ADDENDUM NUMBER 03

DATE: 3/23/2023

PROJECT: MHS Band and Choir Renovation

PROJECT NUMBER: 22-1722

FIRST FLOOR - DEMOLITION
PLAN

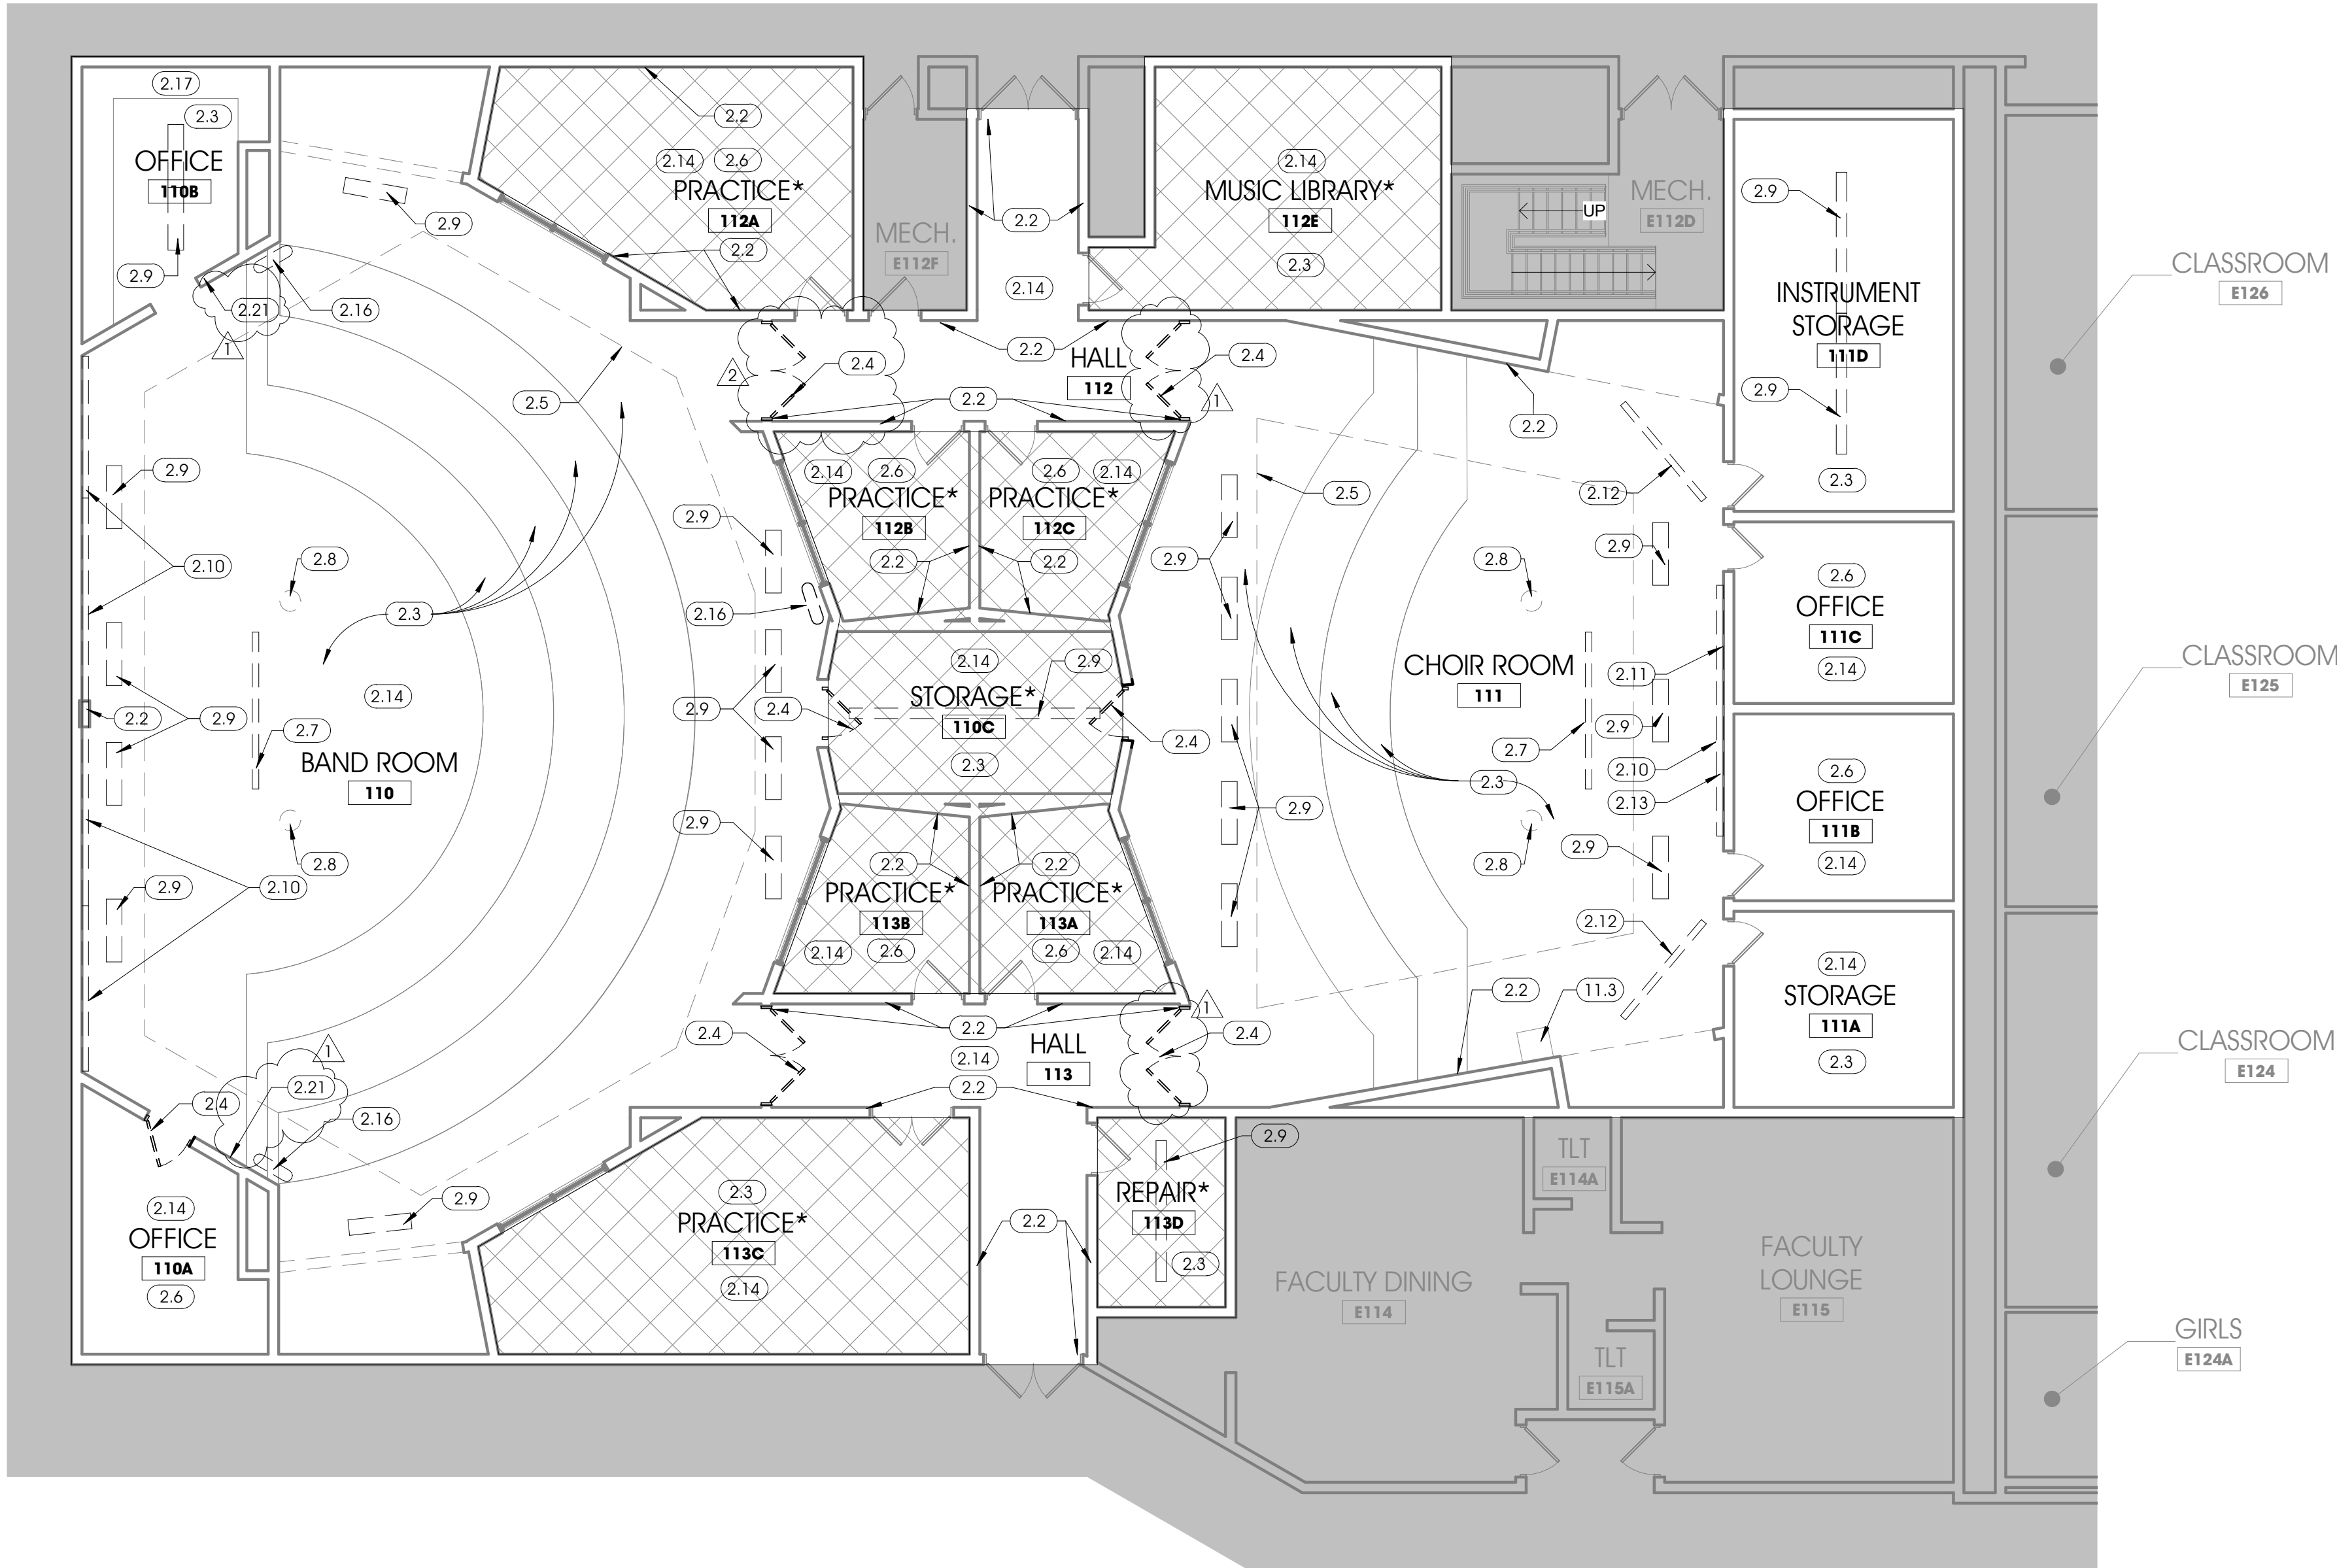
- 4) **ADD** Door 110-A to demolition plan.

FINISH PLAN & DOOR SCHEDULE

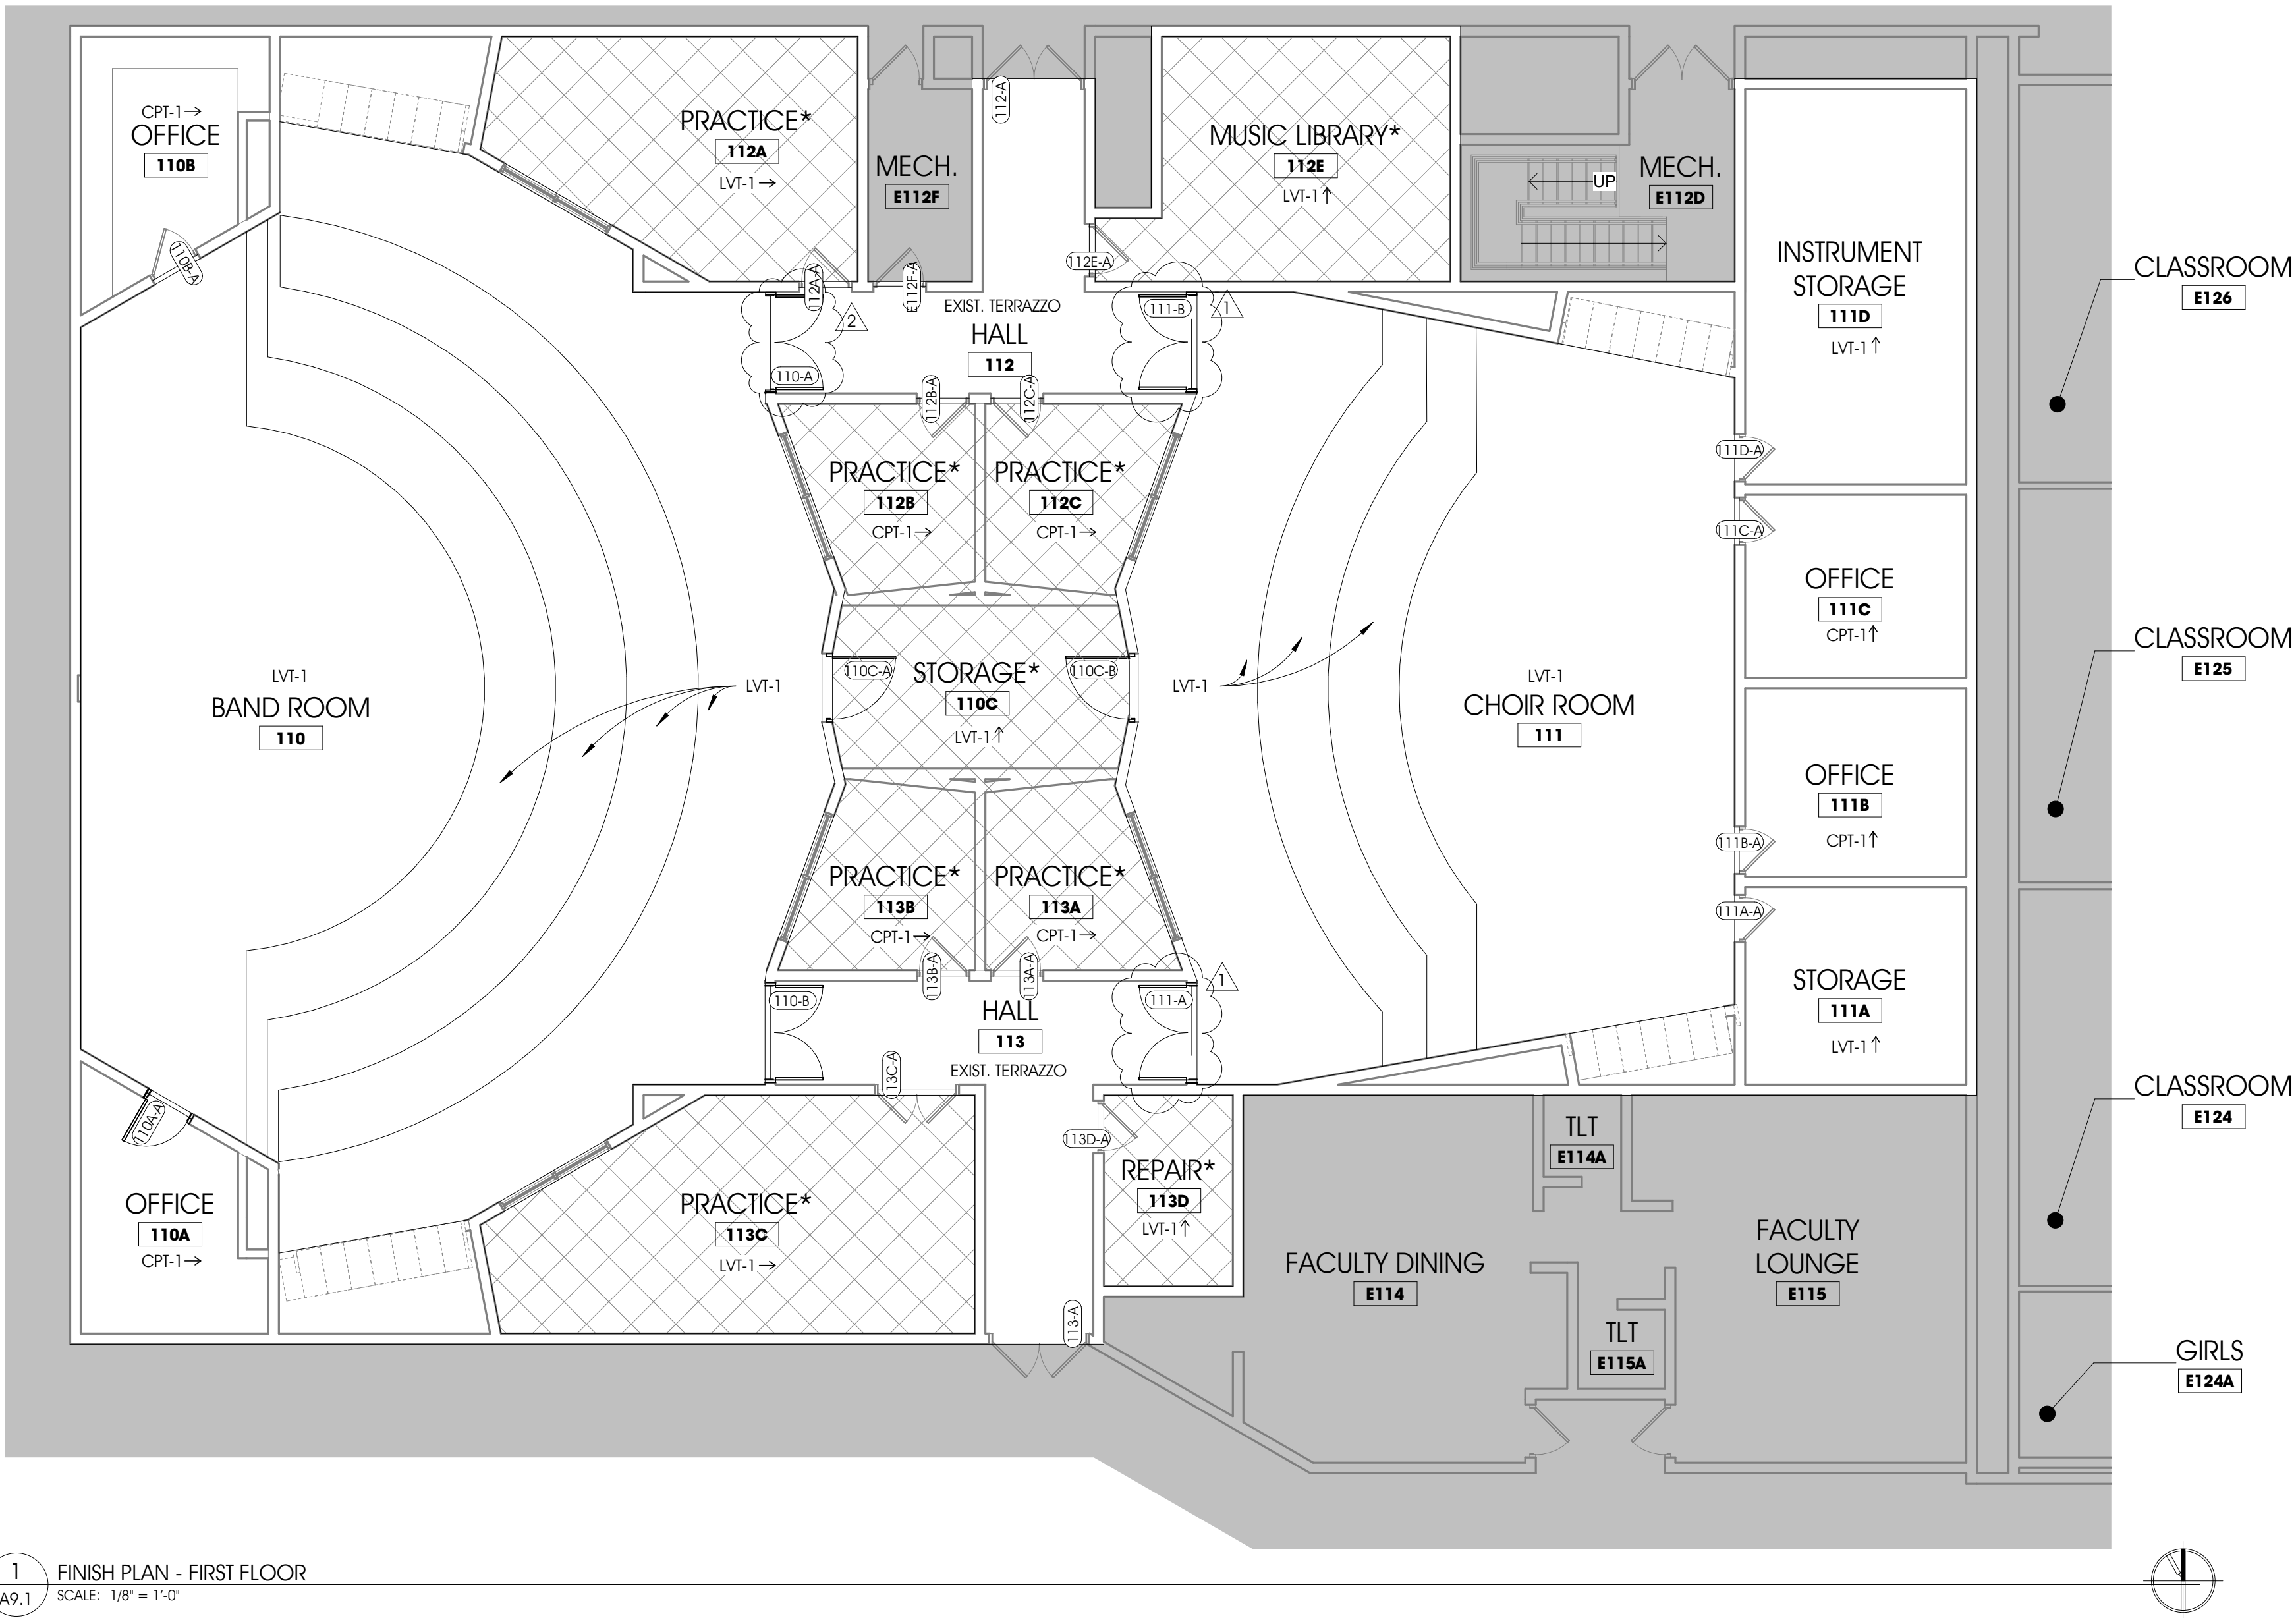
- 5) **EDIT** Notes to DOOR SCHEDULE for more clarification on doors.
- 6) **EDIT** DOOR & FRAME NOTES to add further details on door hardware.
- 7) **EDIT** DOOR HARDWARE GROUPS to give further clarification on door hardware.
- 8) **EDIT** GENERAL NOTES – DOORS to add note to salvage all exist. door hardware

- 9) DOOR & FRAME NOTES – Note B - where does this start and stop?
 - a) Refer to modified door schedule.
